# Access Compliance Report

## Public Rights-of-Way

### (Curb Ramps)

Intersection ID: 10012468	Main Street: IBM_DR	Cross Street: IBM_DR	Location: SE
ADA ID: 71DCB19489D8	Ramp Type: Perp	Initial Pass/Fail: Pass	Overall Compliance: No
			Severity Score: 20.25

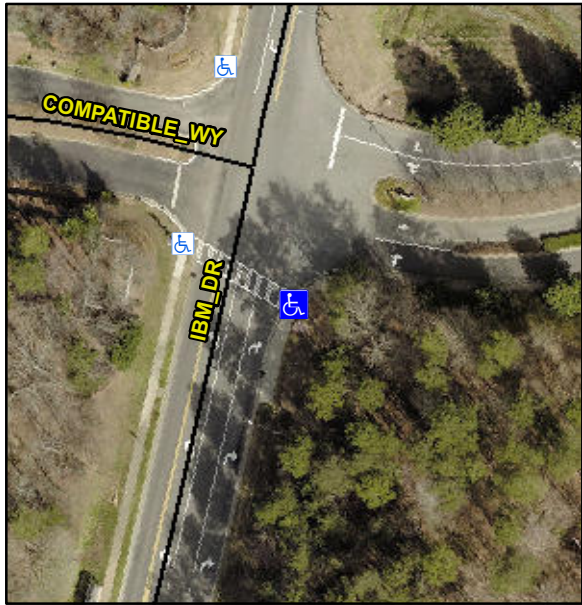
Codes/Mitigation Info/Possible Solution			Field Measurements/Component Compliance					
	Possible Solutions:		Compliance	Description	Data	Compliance	Description	Data
	Remove & Replace Entire Ramp.		N/A	Ramp Length (in)	61.0	Yes	Ramp Slope (%)	5.3
	Remove & Replace Gutter.		Yes	Ramp Width (in)	48.0	No	Ramp XSlope (%)	4.2
			N/A	Flare Type LT	Sloped	N/A	Flare Type RT	N/A
			N/A	Flare Slope LT (%)	5.0	No	Flare Slope RT (%)	12.8
			N/A	Flare Traversable LT?	Yes	N/A	Flare Traversable RT?	Yes
			No	Landing Length (in)	N/A	Yes	DWS Provided?	Yes
			No	Landing Width (in)	N/A	Yes	DWS Contrast?	Yes
			No	Landing Slope (%)	N/A	Yes	DWS Length (in)	24.0
			No	Landing X Slope (%)	N/A	Yes	DWS Full Width?	Yes
Surveyor Notes:		No	Landing Curb? (Y/N)	No	No	DWS Offset (in)	3.5	
N/A		N/A	Shared Landing?	No				
PROW/ADA:		Yes	Gutter Ponding?	No	No	Gutter Slope (%)	5.1	
Not Found, R304.5.3, R304.2.1,		Yes	Gutter Lip Ht (in)	0.0	No	Gutter X Slope (%)	3.9

R304.2.2-Perp, R304.3.2-Para,		N/A	Painted X Walk1?	Yes	N/A	Painted X Walk2?	N/A	
R304.2.3, R305.2, R304.5.4			X Walk 1 Direction	To NW		X Walk 2 Direction	N/A	
		N/A	X Walk 1 Width (in)	111.0	N/A	X Walk 2 Width (in)	N/A	
			X Walk 1 Slope (%)	3.1		X Walk 2 Slope (%)	N/A	
			X Walk 1 X Slope (%)	3.3		X Walk 2 X Slope (%)	N/A	
		Yes	Ramp inside XWalk1?	Yes	N/A	Ramp inside XWalk2?	N/A	
			Road Slope (%)	N/A	N/A	Clear Space?	Yes	
			Road X Slope (%)	N/A	N/A	Clear Space to XWalk (in)	N/A	
		Yes	Any Obstructions?	No	Yes	Storm Grate/Utility Hazard?	No	
			Obstruction Type			Storm Grate/Utility Type		
					N/A		N/A	
					Yes	Surface Condition? (G/P)	Good
